# MEMORANDUM – FINAL DRAFT

**SUBJECT:** Resiliency review consultation services related to the East Arlington Mugar site –  
Final DRAFT for review

Weston & Sampson Engineers, Inc. (Weston & Sampson) is pleased to present this memorandum to the Arlington Land Trust to summarize climate resiliency considerations of the Thorndike Place proposed design at the East Arlington Mugar site (the “Site”) being developed by OakTree Development and designed by BSC Group.

Figure 9. FEMA FIRMeTte for Site

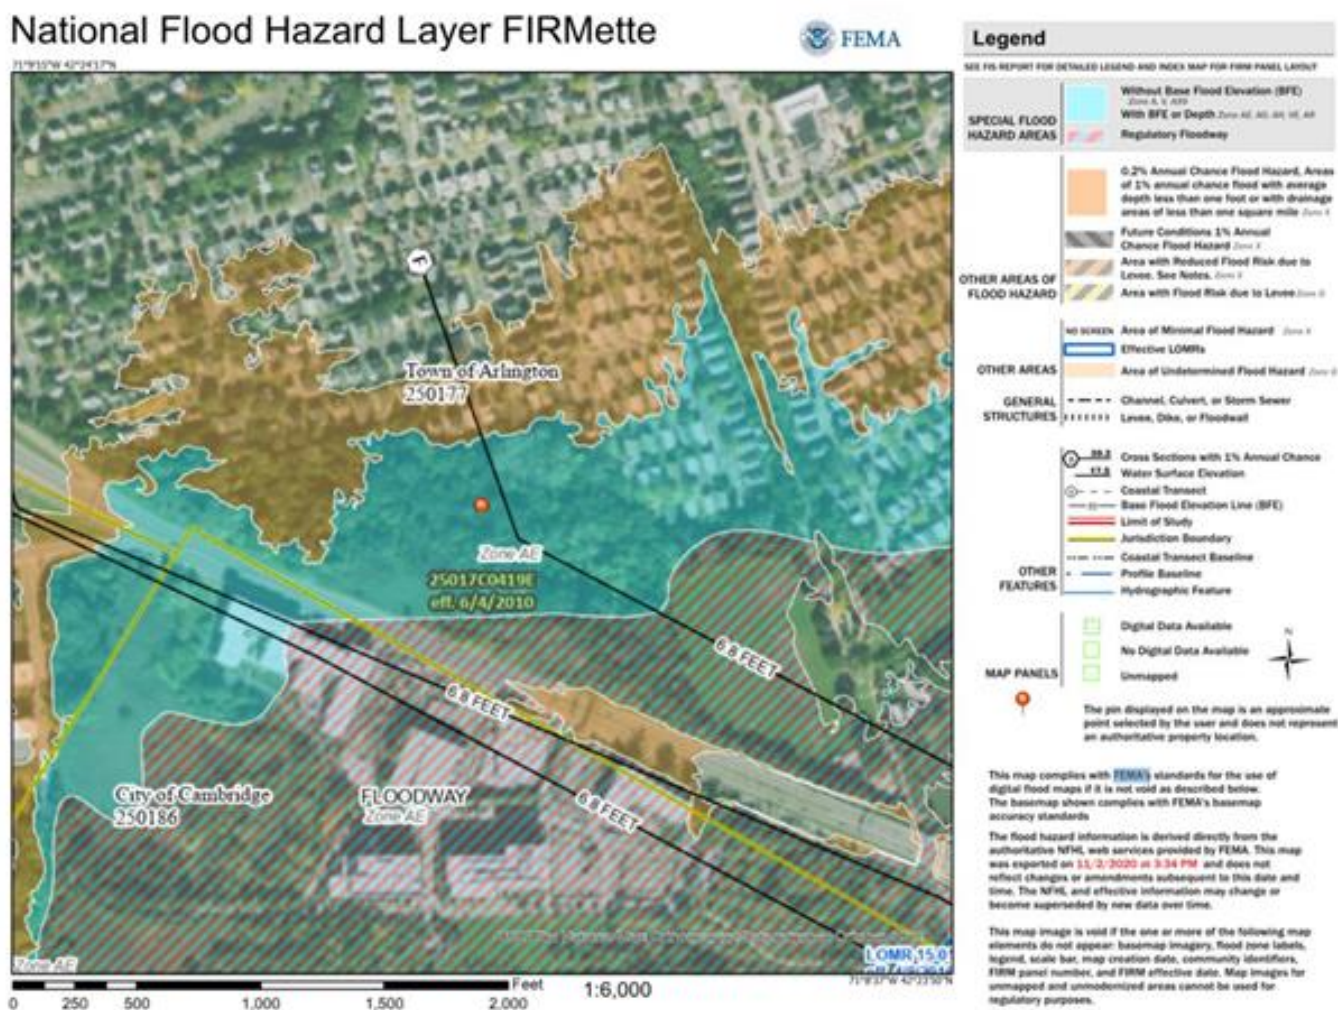
Portions of the Site lie in both the 100-year floodplain and the 500-year floodplain, as established by the Federal Emergency Management Agency (FEMA). Current Massachusetts legislature requires that buildings be designed to the 100-year BFE, which is the elevation that Thorndike Place design relies on at 6.8 feet NAVD88. Although this is the regulatory DFE for Massachusetts developments, FEMA published that, “BFEs reflect estimates of flood risk, but there are many unknown factors that can cause flood heights to rise above the BFE, such as wave action, bridge and culvert openings being blocked by debris, and development in the floodplain. It is important to remember that floods more severe than the 1- percent-annual-chance event can and do occur.”<sup>1</sup> This indicates that designing to the 100-year base flood elevation area may not be enough to prevent flood damage, especially in areas that are prone to flooding. Since the Site is additionally located within the 500-year floodplain, there are further concerns about the current design of the Thorndike Place development. According to flood profiles of

Alewife Brook (Little River)<sup>2</sup> created by FEMA, the 500-year elevation for the Site is 10.75 feet NAVD88. Furthermore, all of FEMA's elevations for the Site are based on data collected up to June 4, 2010, and do not consider SLR or SS effects due to climate change. The first floor living space for the Thorndike Place development is designed at an elevation of approximately 13 feet-NAVD88, making it suitable for projected SLR and SS effects, but the underground parking area is at a severe risk of flooding.

*Figure 10. Map from the BH-FRM showing the 2070 1% Annual Chance Flood*

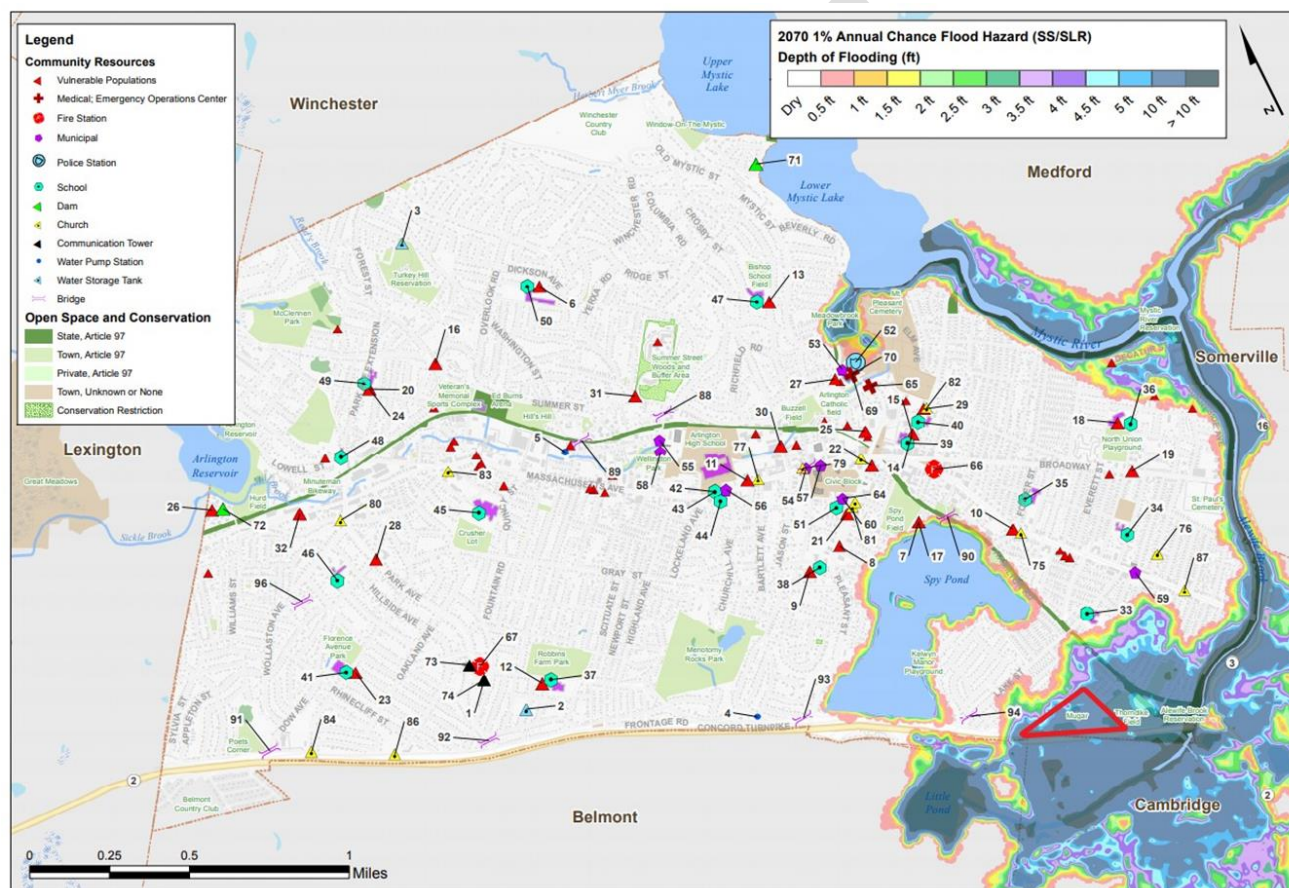
One factor that FEMA's 100-year BFE does not consider is the effect that SLR and SS are predicted to have on nearby infrastructure such as the Amelia Earhart Dam (AED) in Somerville. This dam affects flood elevations along the Mystic River, Lower Mystic Lake, and Alewife Brook (Little River). According to the Cambridge Climate Change Vulnerability Assessment, which utilizes the Boston Harbor Flood Risk Model (BH-FRM), the AED is likely to be flanked by 2045 and overtopped by 2055. If the AED is flanked and overtopped, it implies that the coastal flooding from the Boston Harbor will affect the

proposed development site, and the site is likely to experience a greater than 20% annual probability of flooding by 2070.<sup>3</sup> The Department of Conservation and Recreation (DCR) is actively undertaking a Feasibility Analysis on raising and extending the AED and pursuing this effort in coordination with regional resiliency efforts. The timeline for these improvements is uncertain, which is why the Thorndike Place Development should consider these future flooding impacts. Figure 10 shows a map of the 1% annual chance flood depth projected throughout Arlington for 2070 by the BH-FRM, which was the model used in the Cambridge Climate Change Vulnerability Assessment. This map indicates a projected flood depth of at least 10 feet throughout the Mugar site.

1. Coordinate to discuss flood elevation findings from Climate Change Vulnerability Assessments conducted by surrounding municipalities and utilize the findings to come up with a DFE that would provide flood protection for the 2070s planning horizon.

*Figure 11. Comparison of Total Storm Depths*

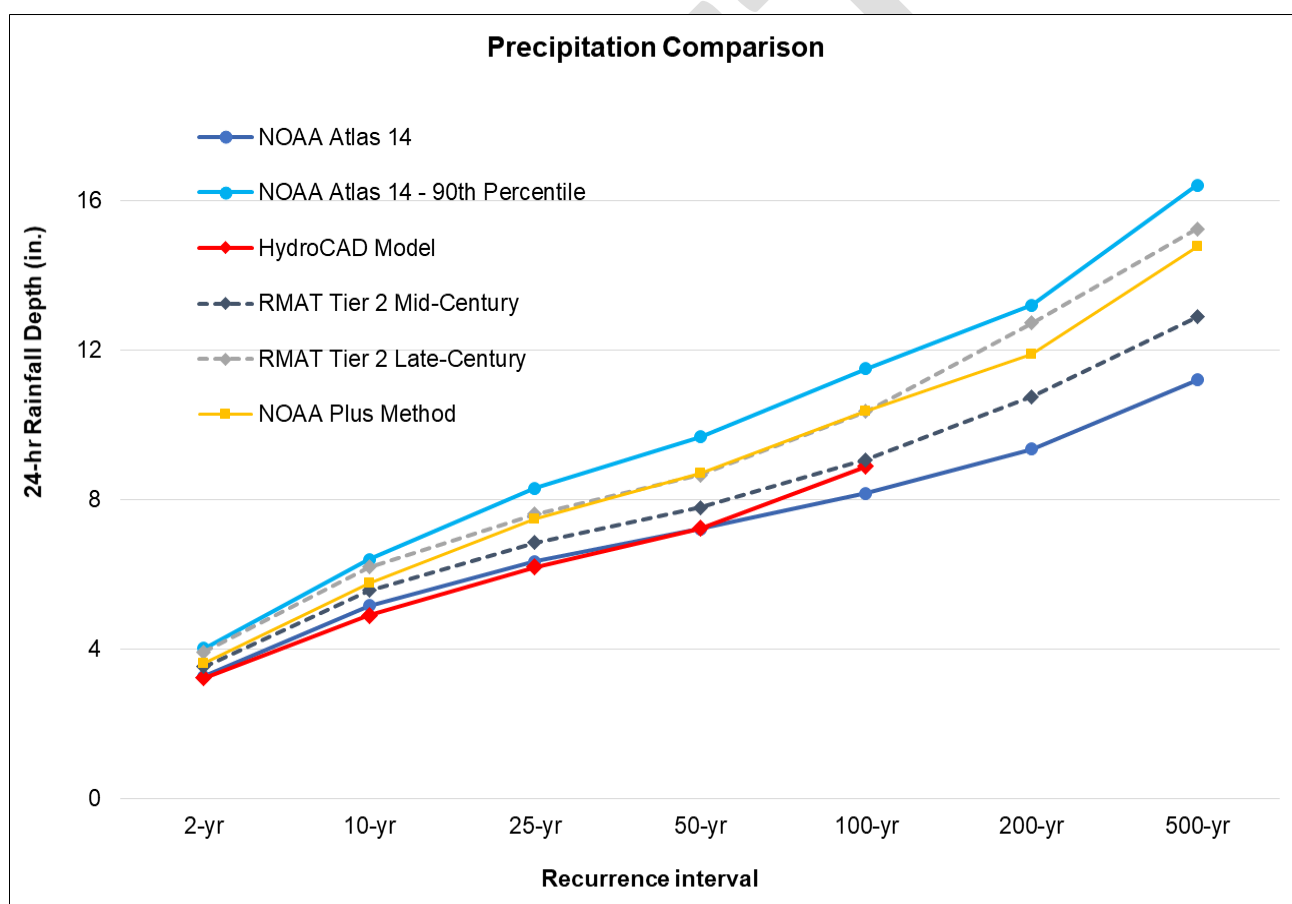
Climate resilient design for the average level of effort ("Tier 2"), as proposed by the RMAT Standards, include percent increases for NOAA Atlas 14 estimates. These percent increases for the mid-century (2030/2050) and late-century (2070/2090) show greater design storm depths than used for the proposed project. A comparative representation of the precipitation depths discussed in this memorandum is shown in Figure 11, with the corresponding values indicated in Table 1, below. It is recommended that these updated precipitation depths be evaluated within the HydroCAD model to appropriately design a stormwater management system at the Site that will be effective in the 2070s planning horizon.

2. Utilize updated 24-hr design storm depths in the HydroCAD model to appropriately design a stormwater management system that will be effective in the 2070s planning horizon. The RMA Tier 2 Methodology provides percent increases to the NOAA Atlas 14 design depths used in the current design of the Thorndike development. The efficacy of the proposed stormwater management at the Site should be assessed using the recommended RMA Tier 2 Late Century percent increases.

Figure 12. Arlington Land Surface Temperature Map, 2018

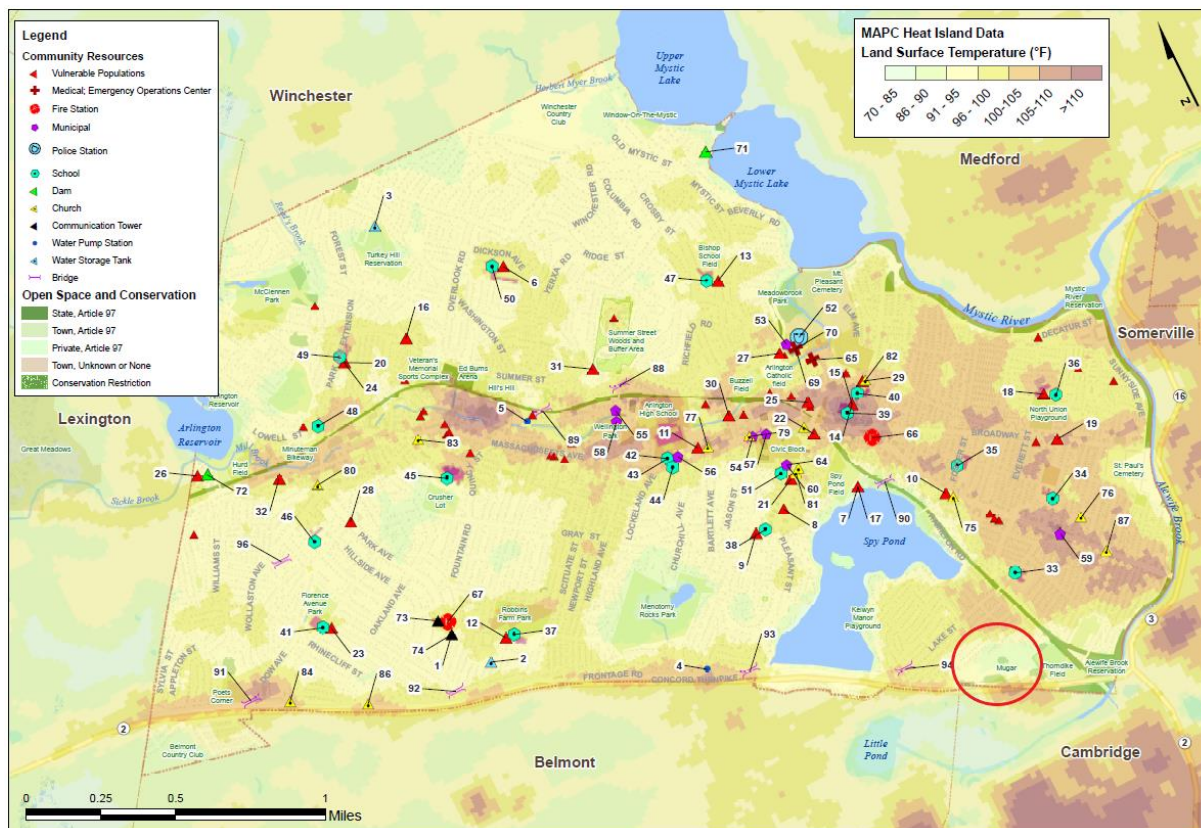
Review of available design documents for the Site does not indicate how development will change land surface temperatures or mitigate the already increasing urban heat island effect. Furthermore, the current Site design does not consider or propose methods to mitigate and protect against future projections for extreme heat.

Taken from the Town of Arlington Community Resilience Building 2018 Report, Figure 12 depicts the current heat island analysis for the Arlington area based on land surface temperature<sup>10</sup>. This figure demonstrates that the Site is one of limited areas within the Town that has lower land surface temperatures. The Cambridge CCVA further shows that ambient air temperatures are projected to increase through 2070, becoming dangerous to human health, worsening the situation for already vulnerable populations expected to be living on the Site<sup>11</sup>.

5. Provide information on how development of the Site will change land surface temperatures to prevent exacerbating the already increasing urban heat island effect.
